Addendum No. 1

WWTP Centrifuge Installation

City of Kodiak Project PN 17-03/7519
Issue Date May 22, 2017

ch2m
PROCESS
TREATMENT BUILDING
CENTRIFUGE SECTIONS

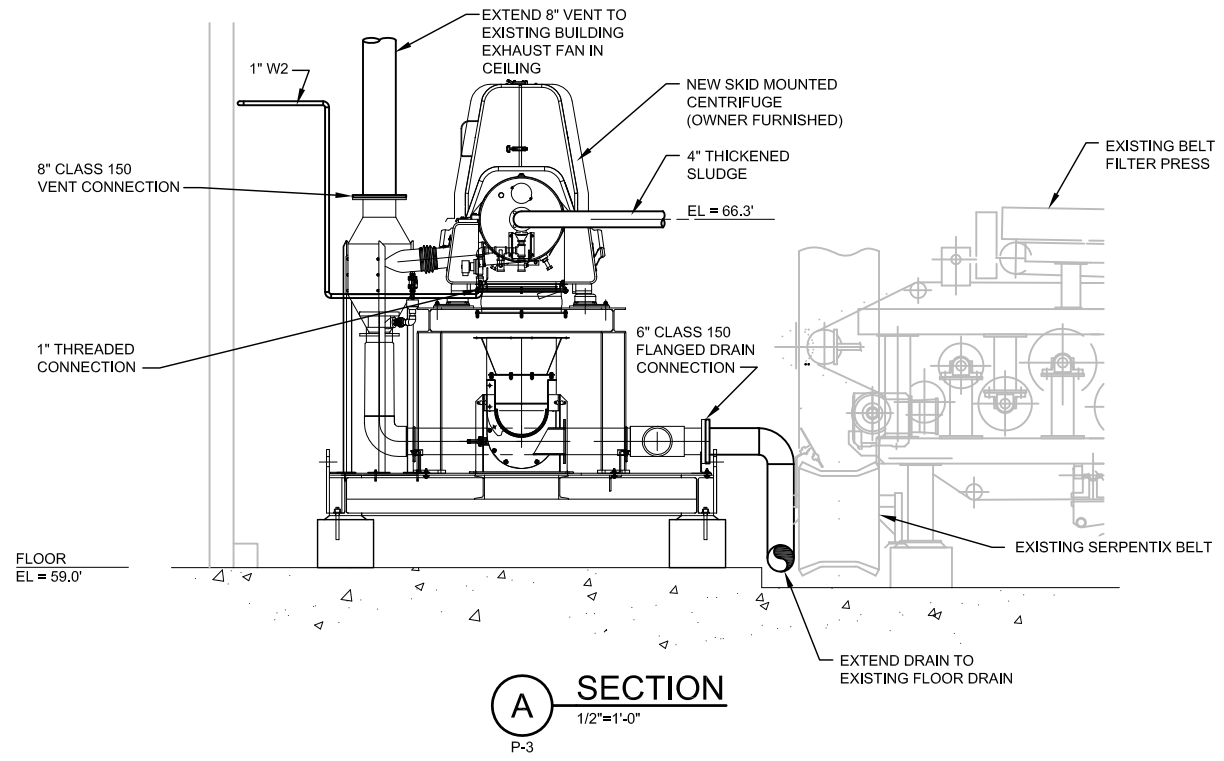
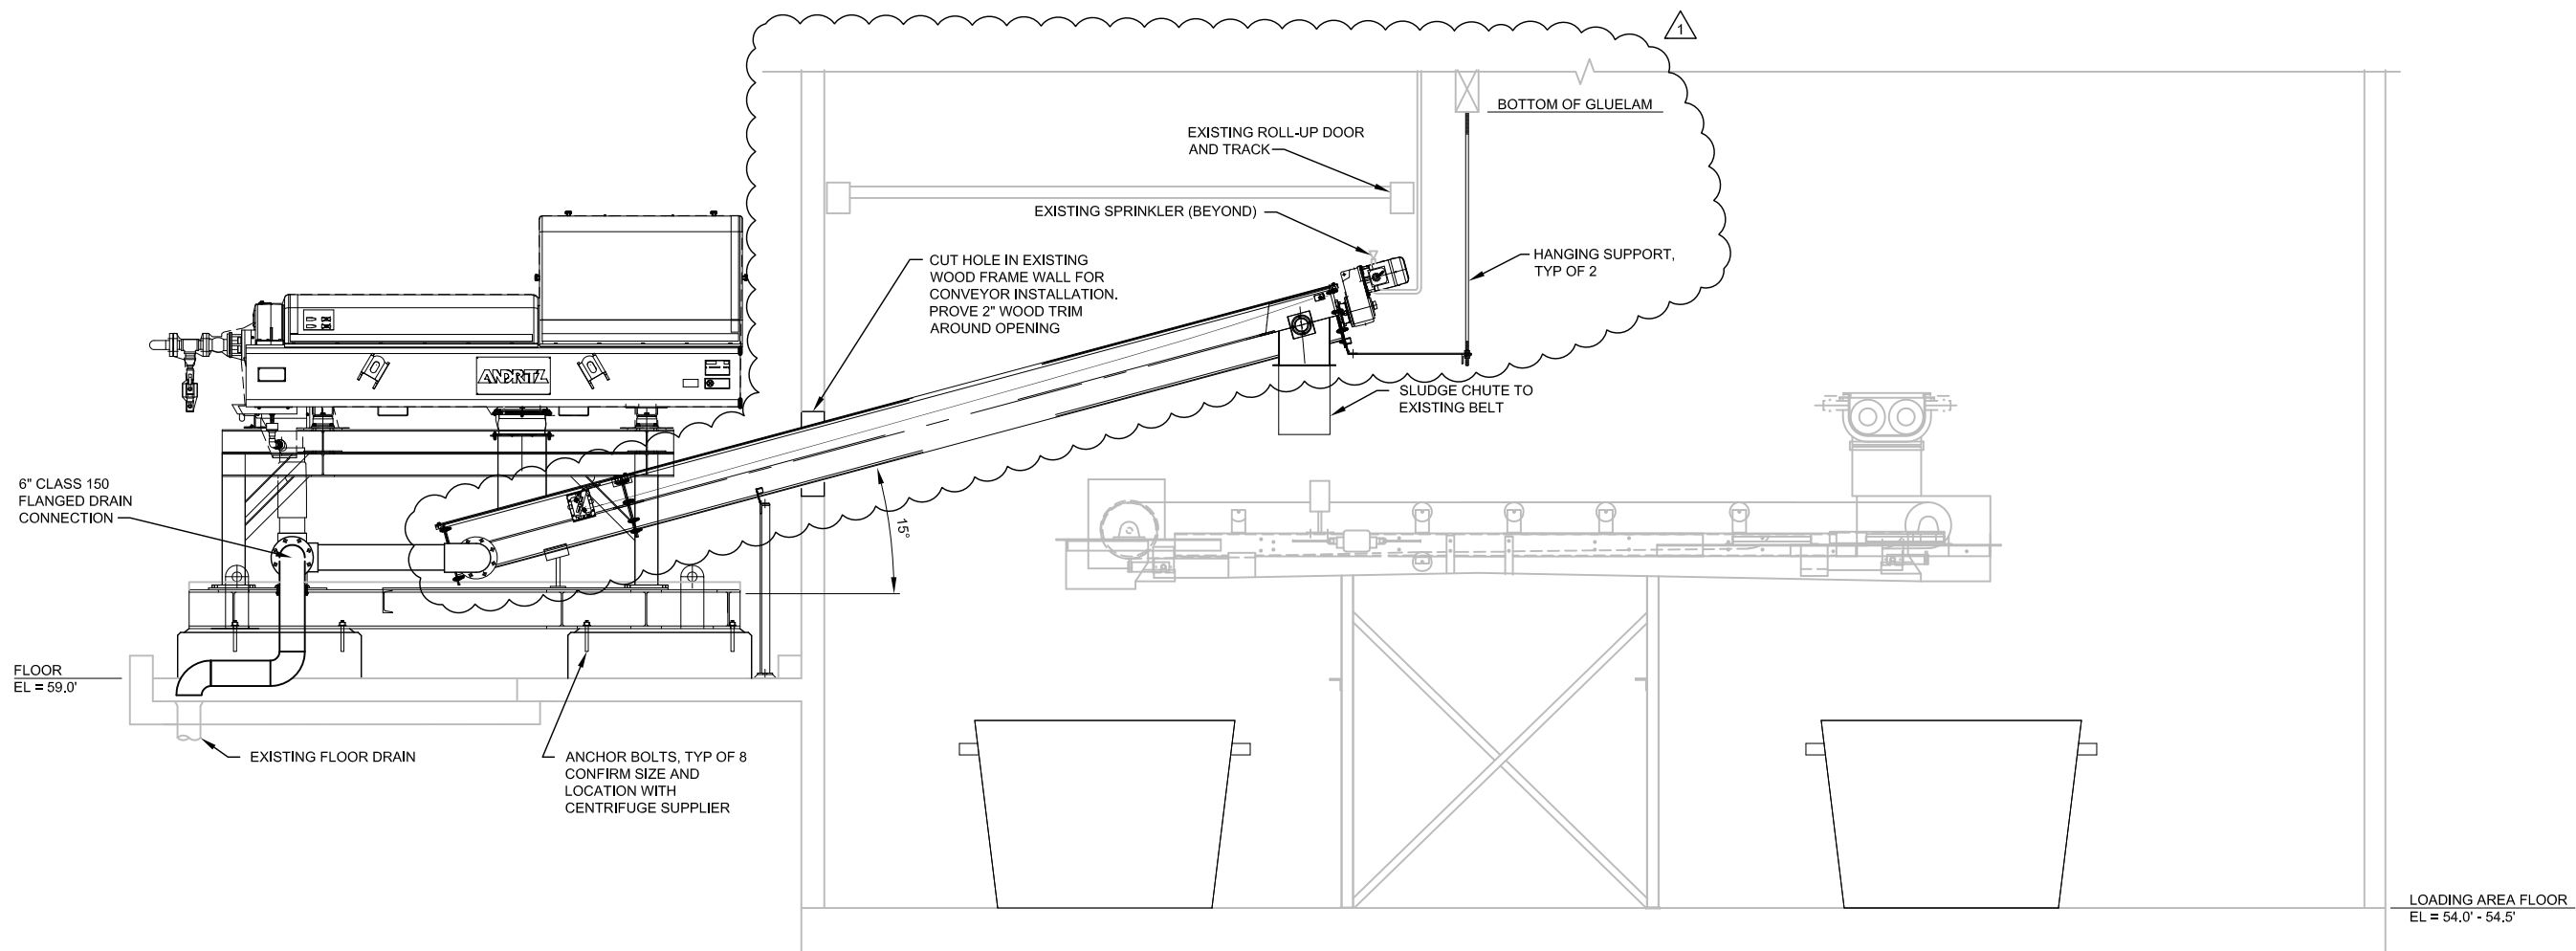
4. DRAWING P-4: REPLACE the Bid set issued Drawing P-4 with the ATTACHED revised Drawing P-4 with revisions dated May 22, 2017.
